**COMMISSION OF ARCHITECTURAL REVIEW
STAFF REPORT
October 24, 2017, Meeting**

11. **COA-024787-2017** (Ridge Point Real Estate) **712 North 27th Street**
Church Hill North Old and Historic District

Project Description: **Construct two story porch at the rear.**

Sanborn Map (1925)

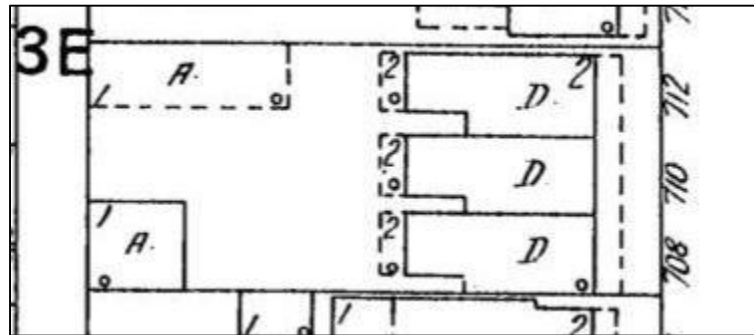
Staff recommends approval of the project with conditions. The *Richmond Old and Historic Districts Handbook and Design Review Guidelines* note that a porch replacement should match the original as much as possible (pg. 71, #5). Staff does not have any photographic or physical evidence of the design of the historic porch structures at the rear other than the location illustrated on the Sanborn map. As the proposed porch is in the location of the historic porch

based on the Sanborn map and is of a similar design to the porch structure on the attached home, staff supports the reconstruction of a two story open porch at this location. Staff supports the use of Richmond rail as the Guidelines note that it is an appropriate design when there is no evidence of the design of the historic railing (pg. 49, Porches and Porch Details #2). Staff recommends the porch structure be painted or opaquely stained a neutral color that complements one or more of the colors found on the main structure and the colors be submitted to staff for administrative review and approval.
